CONSTRUCTION SUMMARY

Grovetrail Developments Inc.

LOT NUMBER	PHASE	HOUSE TYPE	CLOSING DATE
137	2	BELVEDERE Elev B	27-Nov-25

Date Added: 07-Jan-25

LOT 137 38-11. BELVEDERE. EL.B. 2670 sq.ft.

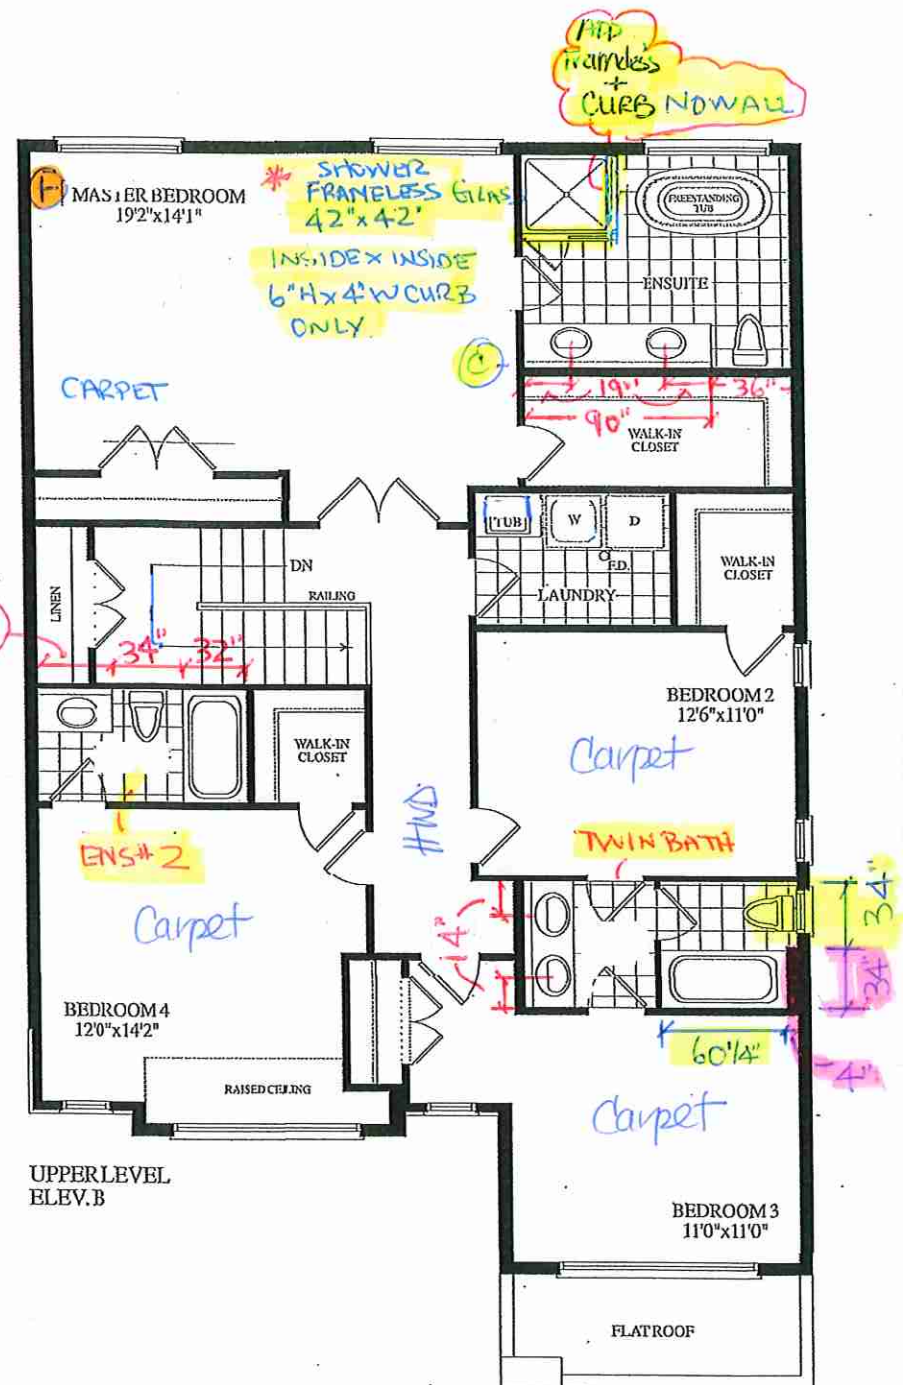
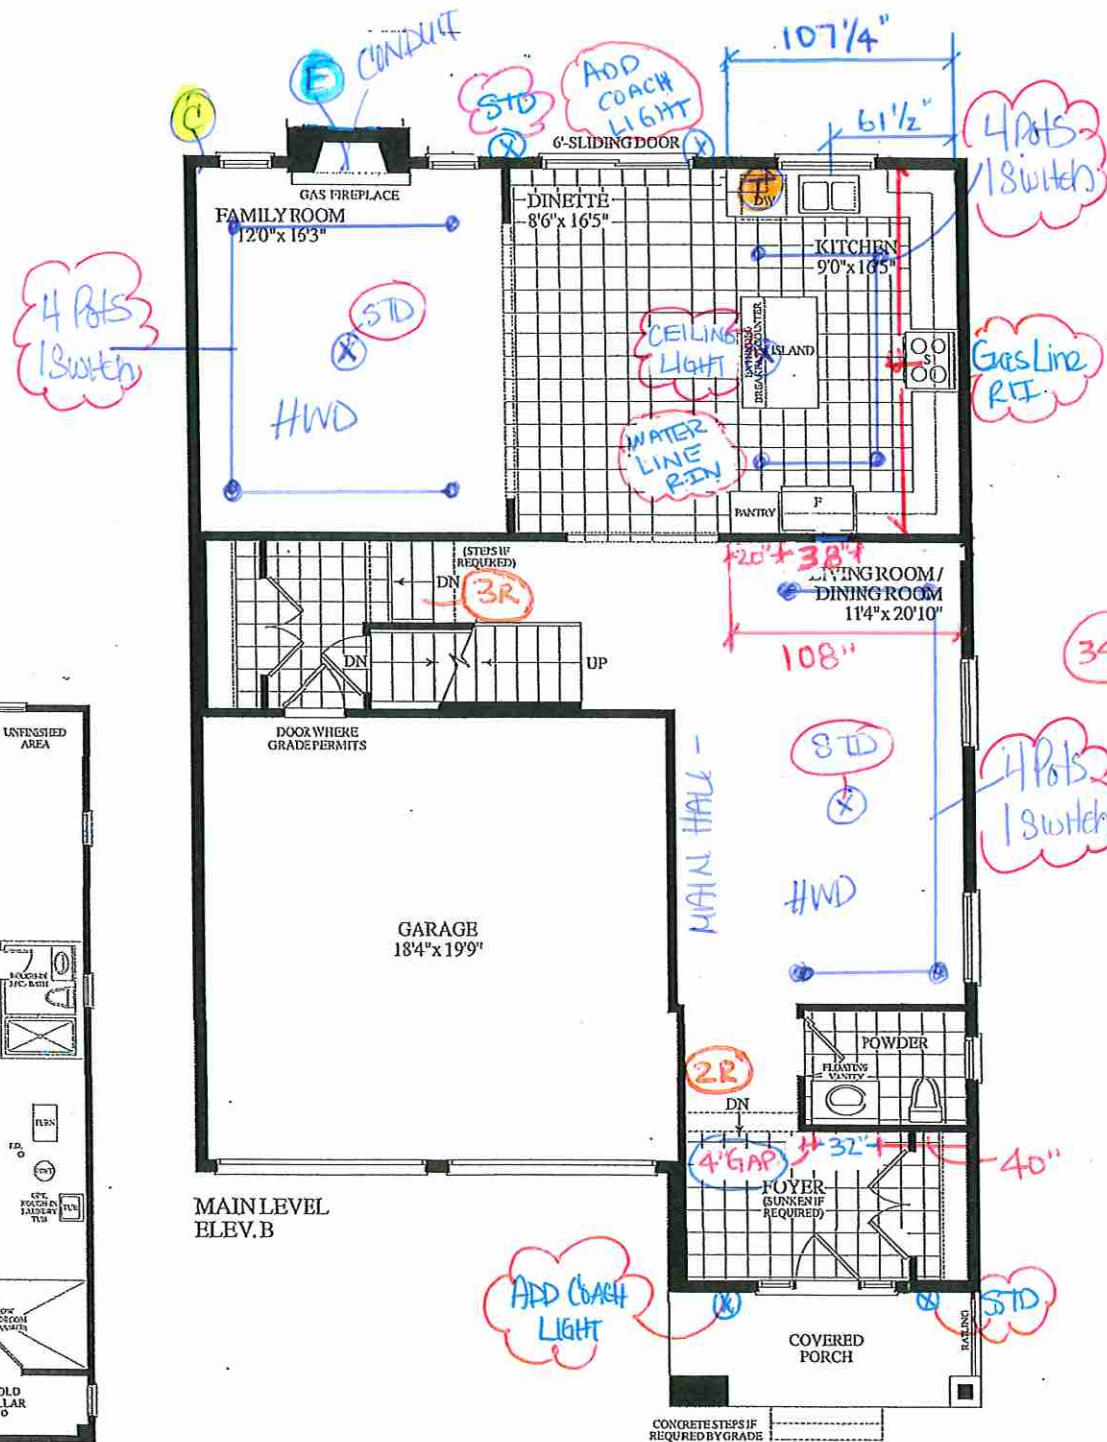
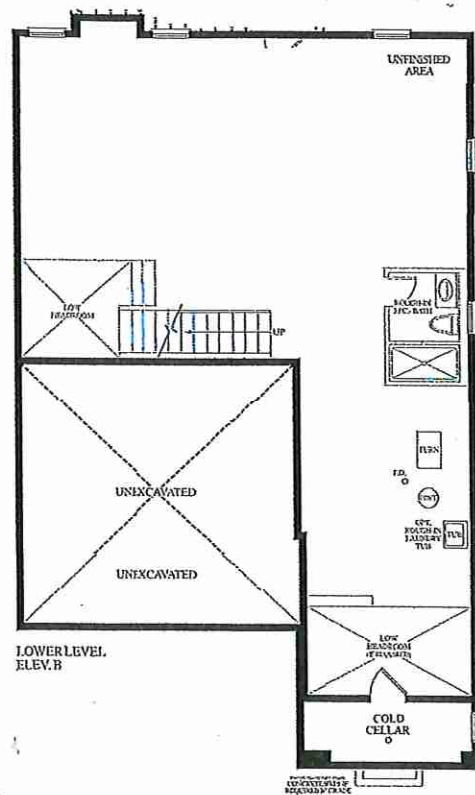
1 - Install standard Cable / Cat 6, Telephone (See Sketch)
Note:

1 - FAMILY ROOM- Install an electrical plug above the fireplace to accommodate the TV above the fireplace. To be installed above the mantle 60" AFF (See Sketch)
Note:

1 - FAMILY ROOM- Raise the Conduit pipe to above the fireplace to accommodate the TV above the fireplace. To be installed above the mantle 60" AFF (See Sketch)
Note:

1 - Purchaser to receive TEN (X10) Potlights on Main floor as per their Standard Features and Finishes List
SEE BELOW
Note:

1 - KITCHEN- Relocate the builders standard ceiling light in the kitchen to above the kitchen island (See Sketch)
Note:

1 - KITCHEN- In addition to the builders standard ceiling light above the isalnd, Install FOUR (X4) Pot Lights in the kitchen. All FOUR (X4) potlights to be on its own separeate switch(See Sketch)
Note:

1 - FAMILY ROOM- In addition to the builders standard ceiling light in the family room, Install FOUR (X4) Pot Lights in the Family Room. All FOUR (X4) potlights to be on its own separeate switch (See Sketch)
Note:

1 - DINING/LIVING ROOM- Shift the builders standard ceiling light, to be centred with in the Dining Room and Living Room (See Sketch)
Note:

2 - DINING /LIVING ROOM- Install FOUR (x4) pot lights in the Living Room and Dining Room. All FOUR (X4) Pot Lights to be on their own seperate switch.
Note: **PLEASE NOTE**- Purchaser has been charged for TWO (X2) pot lights.

1 - KITCHEN- Install a Water Line Rough In to fridge (See Sketch)
Note:

1 - KITCHEN- Install a Gas Line Rough In to stove (see Sketch)
Note:

1 - FRONT EXTERIOR- Install an additional coach light, next to the front door, opposite standard. To be on the same switch as standard coach Light (See Sketch)
Note:

1 - BACK EXTERIOR- Install an additional coach light, next to the back patio sliders, opposite standard. To be on the same switch as standard coach Light (See Sketch)
Note:

1 - MASTER ENSUITE SHOWER STALL- Delete the full wall next to the free standing tub, and install frameless glass shower. To include additional curb with stone quartz top and frameless glass (See Sketch)
Note:

- ① CABLE (X2)
- ② TELEPHONE (X2)
- ③ ELECTRICAL (X1)
- X10 POTLIGHTS
